**SUBJECT: Comment Letter: Draft Policy for Toxicity Assessment and Control**

CLEAN WATER ASSOCIATION  
TECHNICAL COMMENTS  
PROPOSED POLICY FOR TOXICITY ASSESSMENT AND CONTROL

**Figure 1.** Fathead minnow survival effects between 0% and 25%. All tests conducted by the Districts San Jose Creek Water Quality Laboratory in 2009.

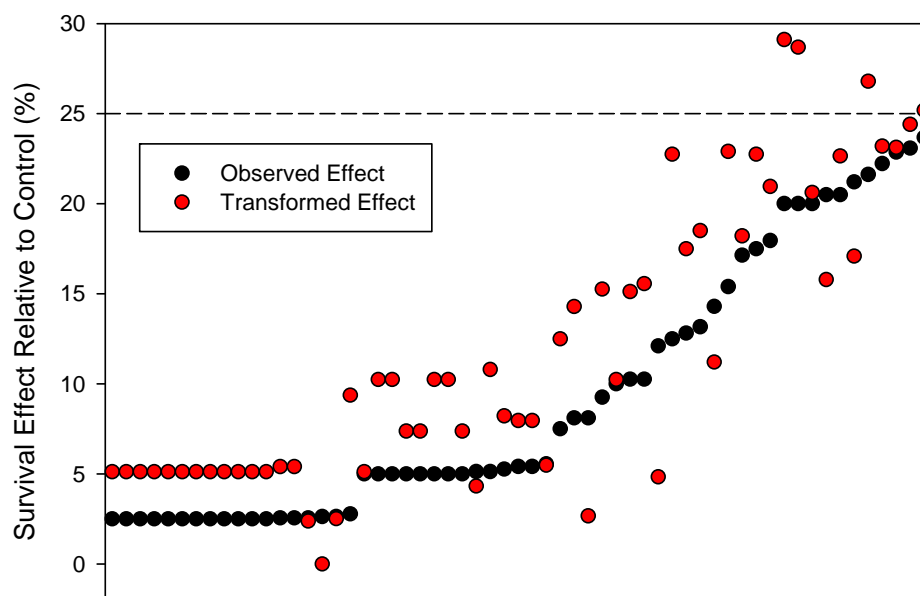
11.20 → 14. The Arc-sine Square Root Transformed Data Contains an Apparent Bias.

Transforming percentage data (e.g., survival responses) is a commonly accepted practice prior to conducting hypothesis testing where normal distribution assumptions are critical in the statistical analysis. When using the commonly applied arc-sine transformation, a bias resulting in the calculated response or effect using the transformed data is typically greater than the actual observed response or effect. This bias poses little concern when traditional hypothesis testing is conducted because all transformed treatments are compared directly to the transformed control. However, with the TST hypothesis test, the transformed treatments are compared to 75% of the transformed control. By not similarly transforming the binomial “b” or bioequivalency factor (75% for chronic tests and 80% for acute tests), this bias will significantly increase the probability of identifying a sample as toxic. The effect and magnitude of this bias in real world samples exhibiting observed effects ranging from zero (0) to 25% are presented in Figure 2.

11.20 → a. All Calculated Effects Should Be Determined Using Untransformed Data.

The fathead minnow survival data example contained on page 22 of the Revised Draft Policy calculates the percent effect in the instream waste concentration (IWC) using arc-sine transformed survival data as represented below:

After reviewing the EPA's TST spreadsheet tool (version 1.5), it is clear that all effects are to be calculated using original, not transformed data. Considering that there is significant positive bias associated with calculating percent effects at the IWC using transformed data, EPA TST tools calculate percent effects using untransformed data, and that accurate calculations of these estimates are critical for reasonable potential determination, MDEL evaluation, and TRE trigger determination, all references and examples in the Revised Draft Policy should clearly indicate that original units are to be used for these calculations.
